**NEXTERA ENERGY POINT BEACH, LLC
POINT BEACH NUCLEAR PLANT, UNITS 1 AND 2**

**LICENSE AMENDMENT REQUEST 261
EXTENDED POWER UPRATE**

NON-PROPRIETARY RESPONSE TO REQUEST FOR ADDITIONAL INFORMATION

December, 2009

Figure 5a: Core Exit Vapor Flow

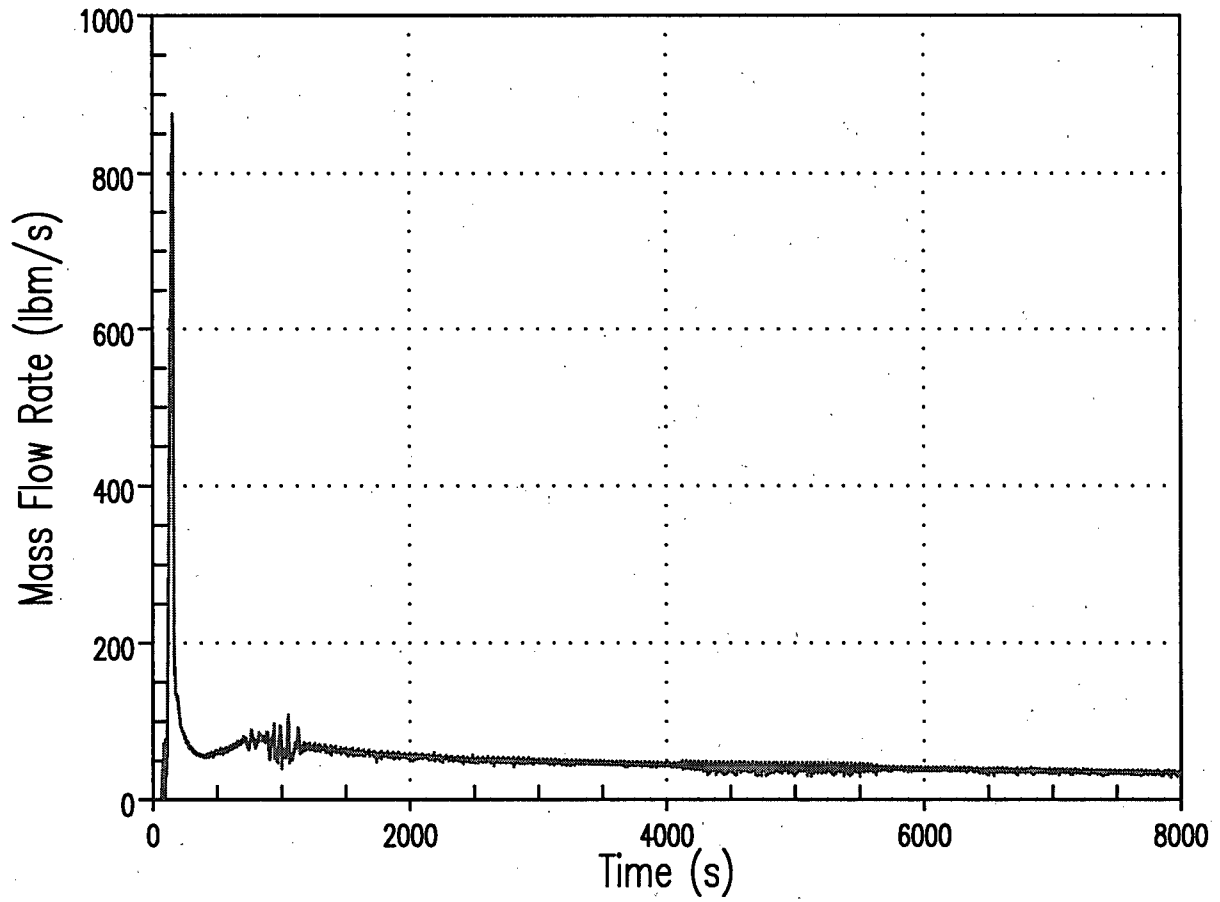
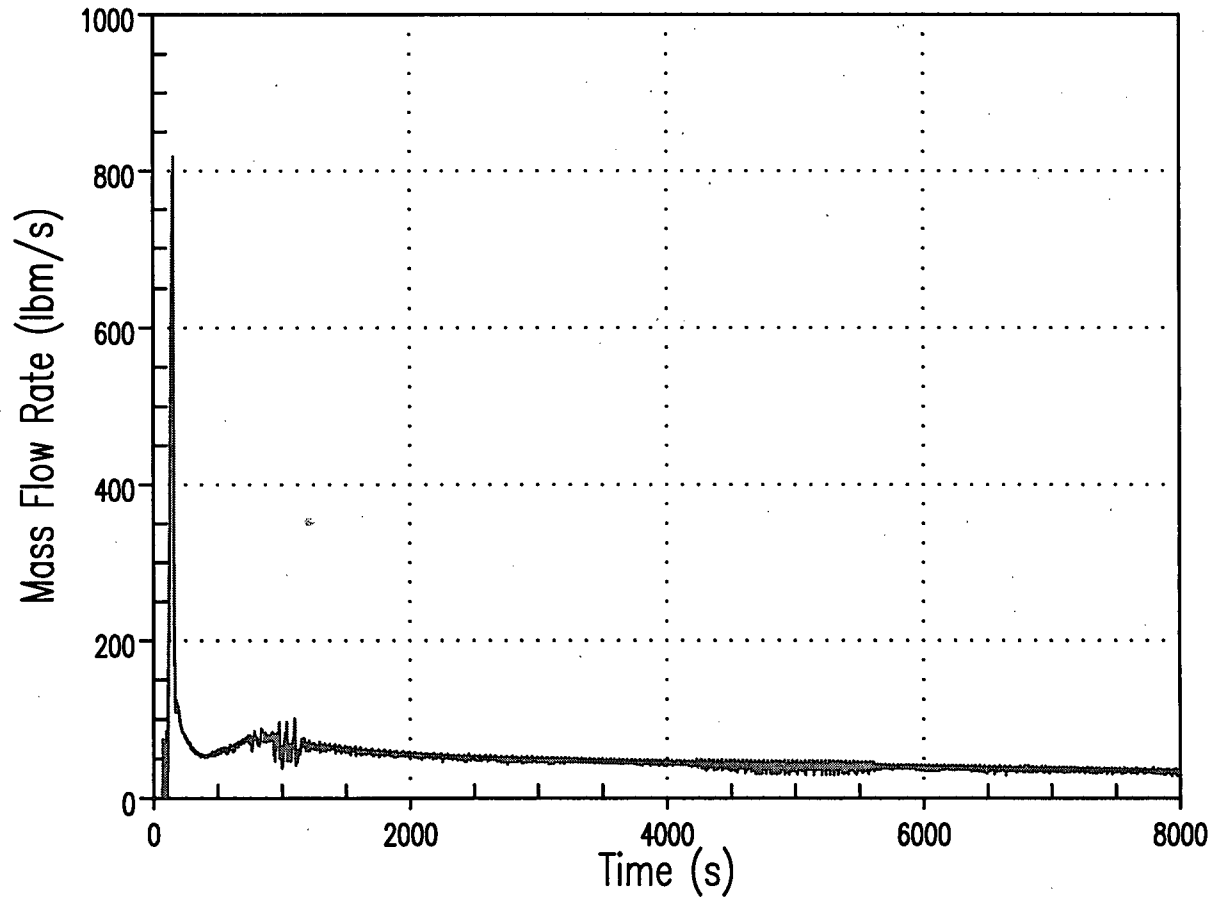
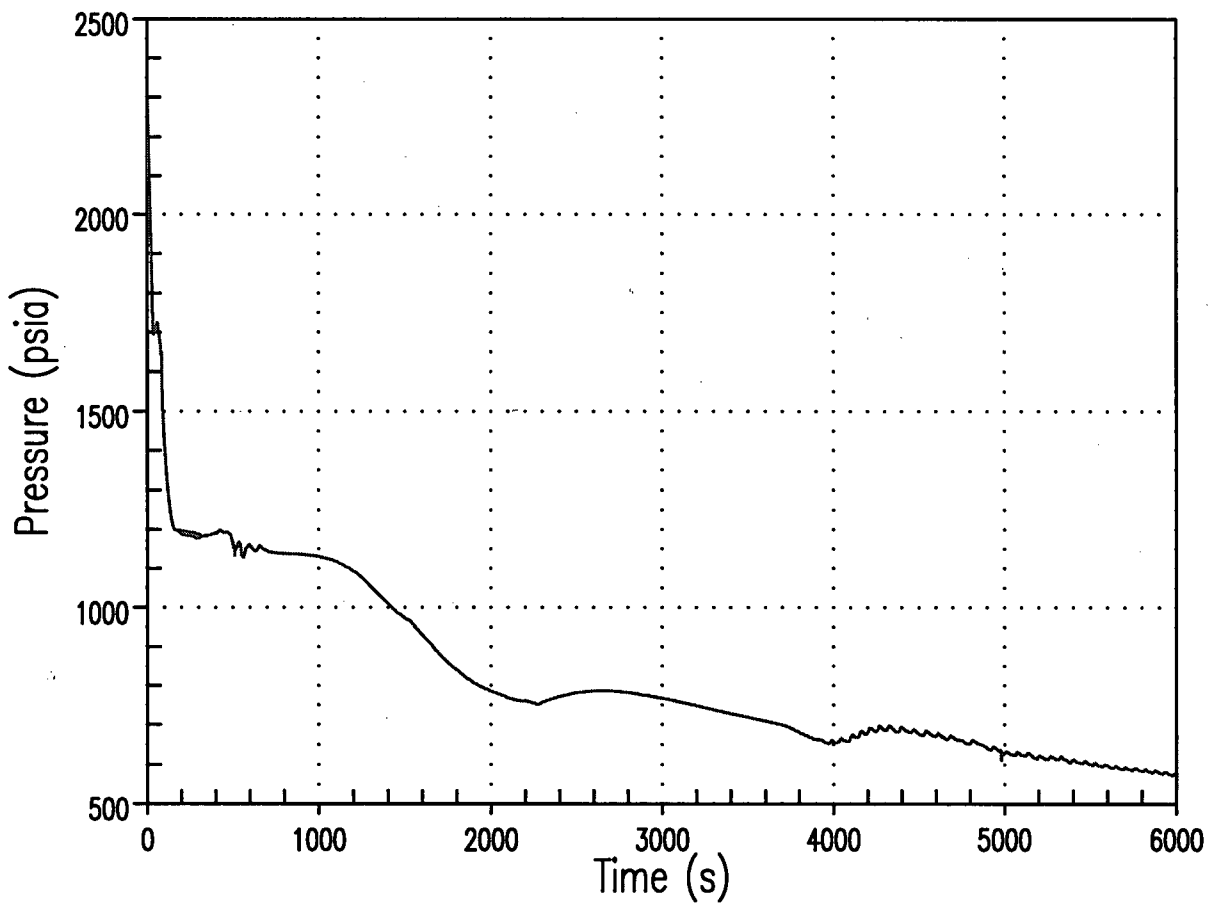
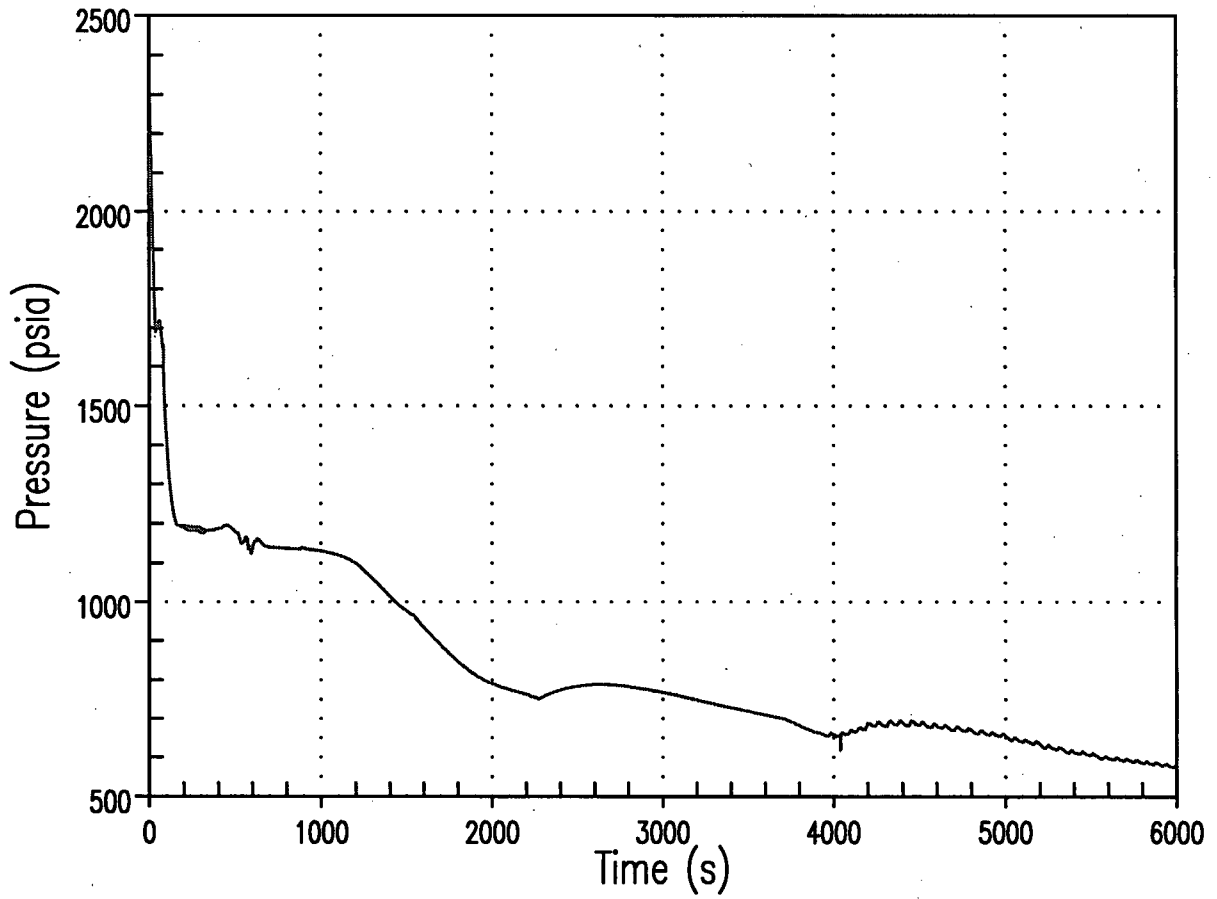
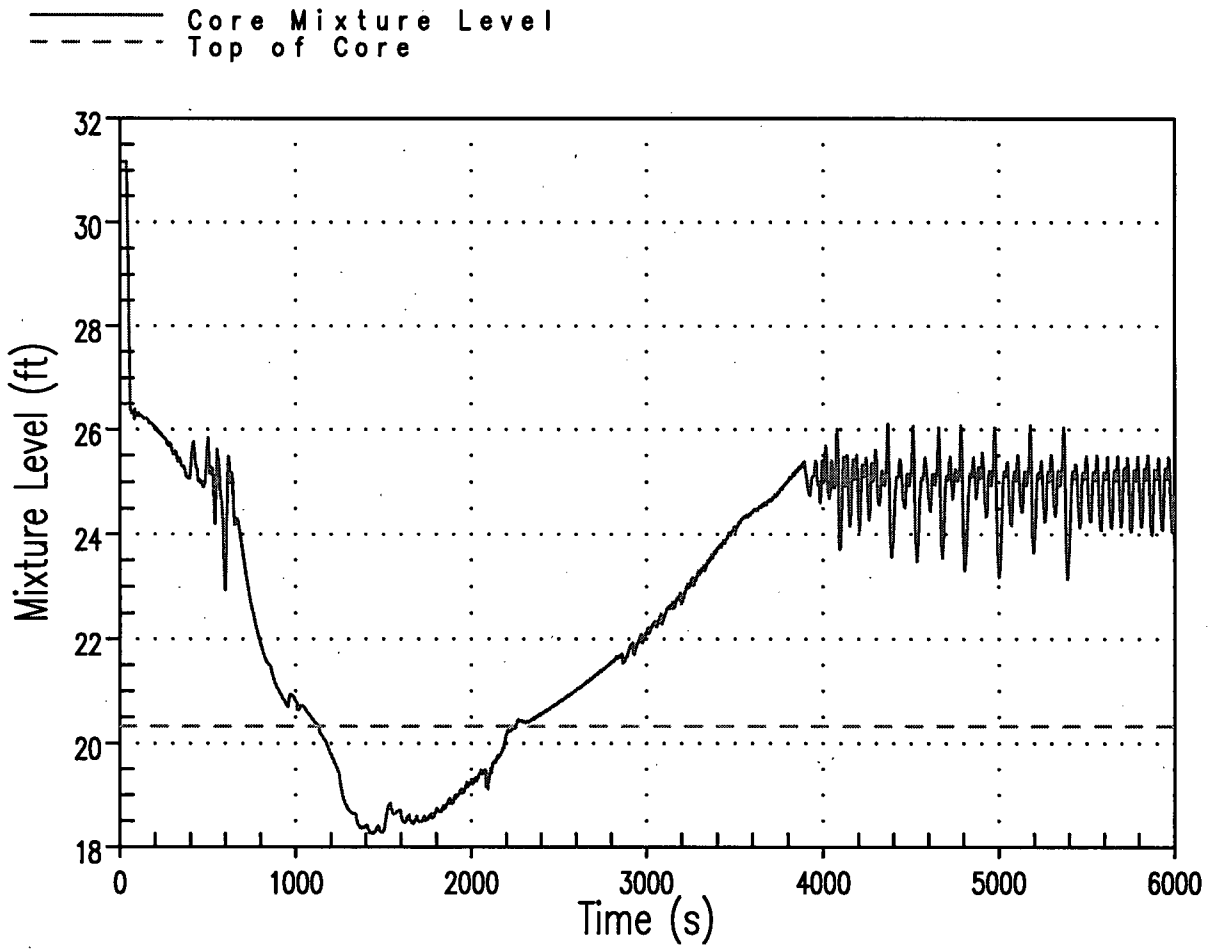
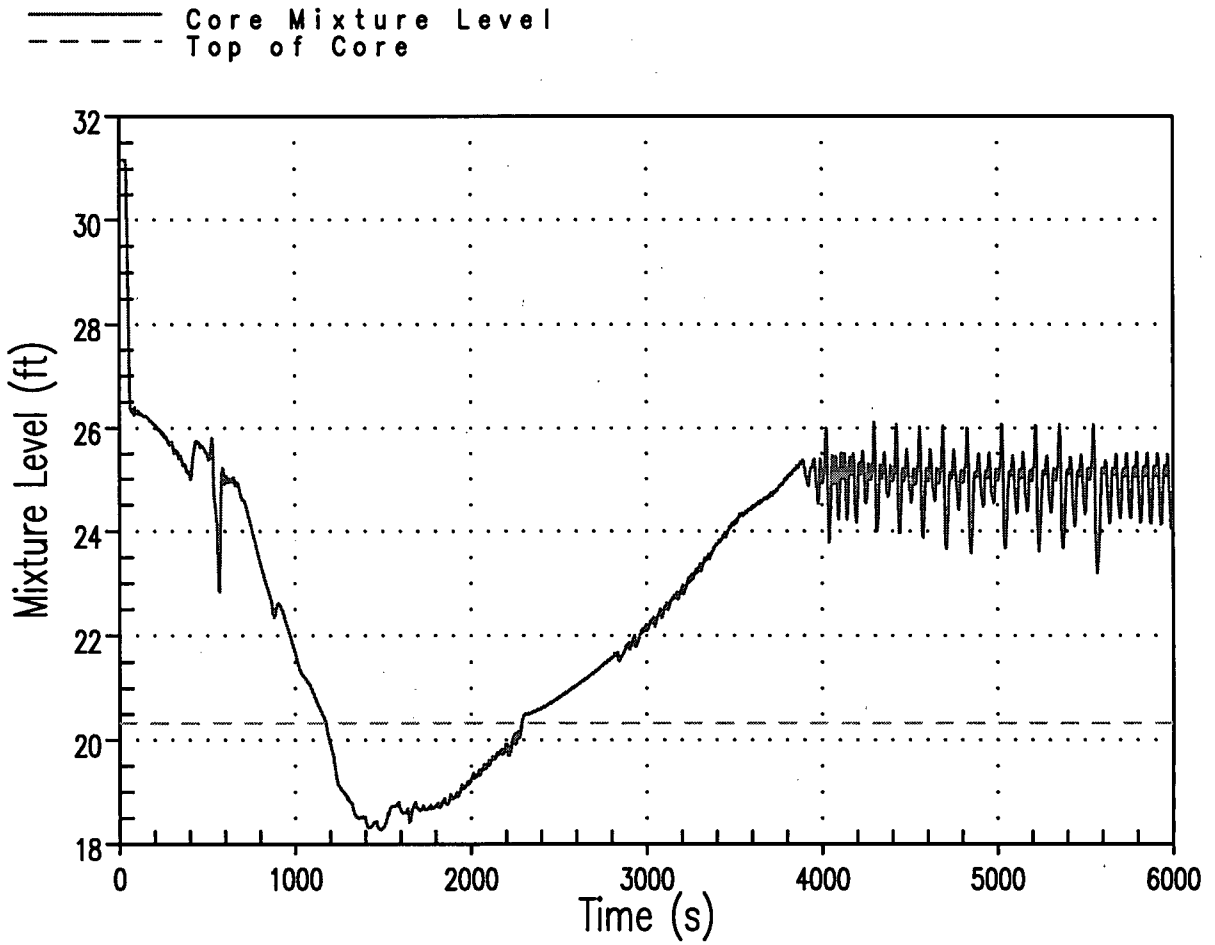
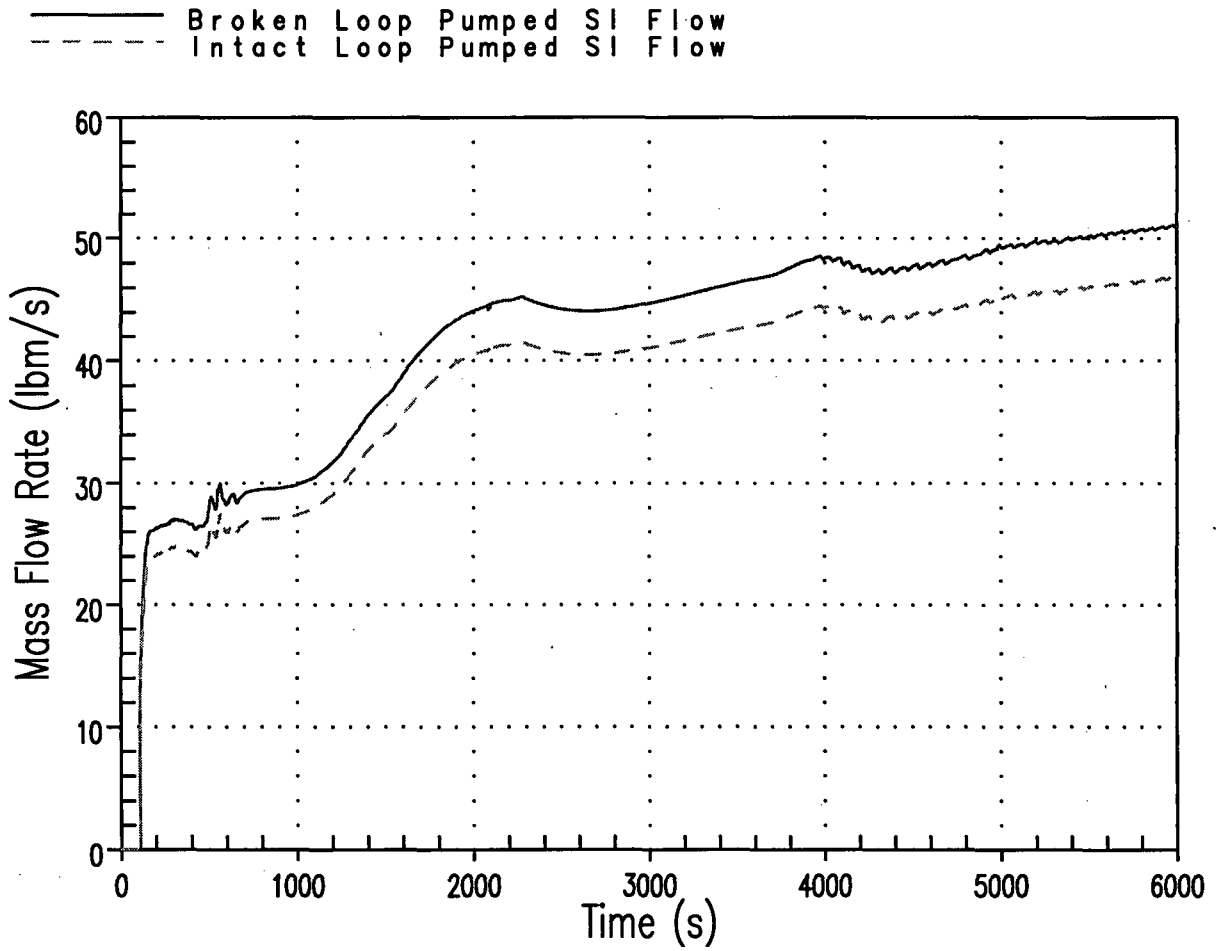
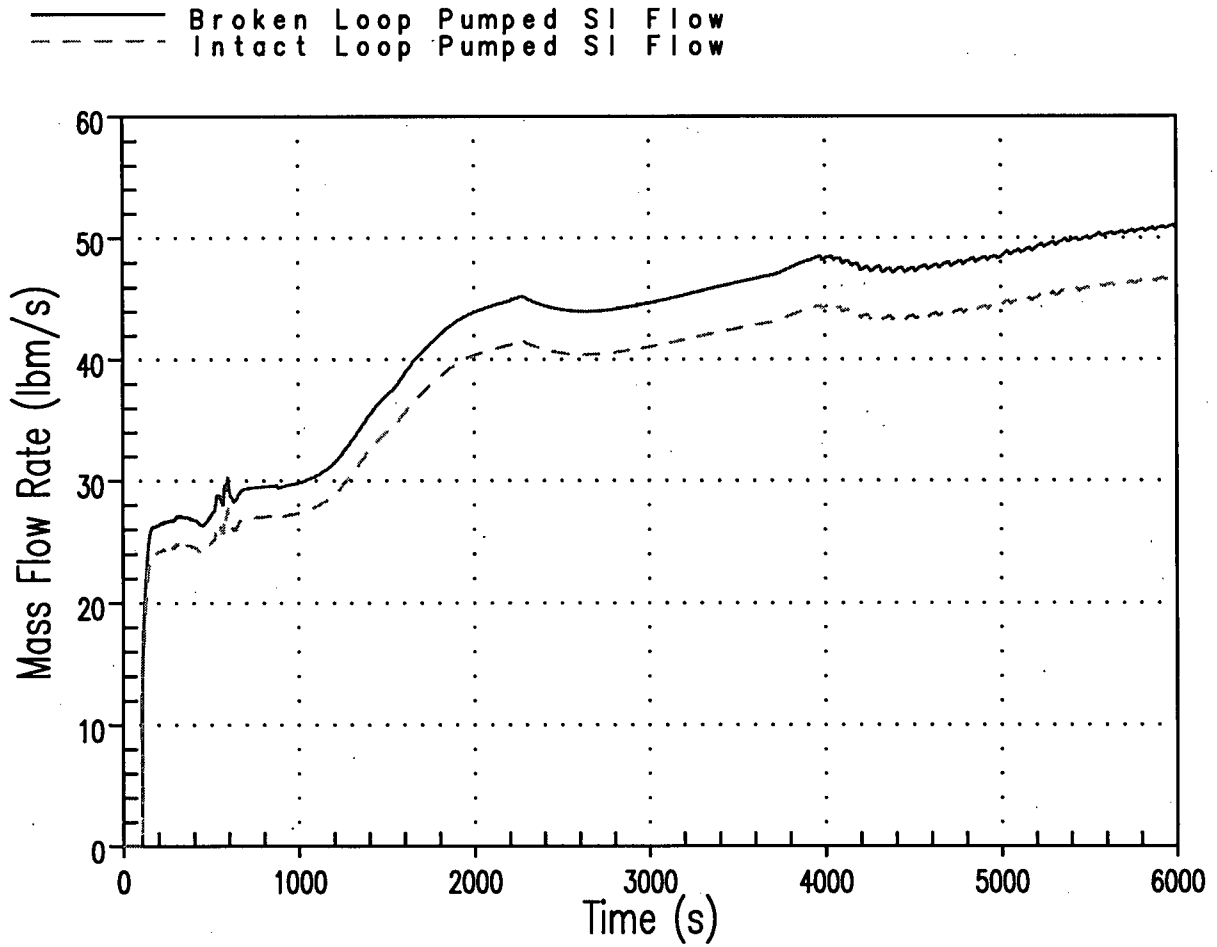
- 1) Page 2.8.5.6.3-6 of the Point Beach Extended Power Uprate (EPU) Licensing Report (Enclosure 5 to Reference 1) indicates that the small-break loss-of-coolant accident analysis was performed using the NOTRUMP evaluation model. Please provide a copy of the NOTRUMP analysis report that supports the EPU application.**

The NRC reviewer provided clarification of this RAI during a teleconference held between Westinghouse, FP&L, and the NRC. It was concluded that the transient response results of the non-limiting breaks, which are not provided in the LAR, will be provided. Transient response results for the limiting 3-inch break for both Point Beach Units 1 and 2 are provided in the small break LOCA LAR Section 2.8.5.6.3. The same response results for the non-limiting breaks are provided below. The following comments apply:

- Peak cladding temperature transients are not provided for the 6- and 8.75-inch breaks as these breaks experienced little to no core uncover.
- Low head safety injection flow figures are provided only for the 6- and 8.75-inch breaks. LHSI was only modeled for the 6- and 8.75-inch breaks (during RWST injection phase only). Breaks less than 6-inches in equivalent diameter did not reach the LHSI cut-in pressure.
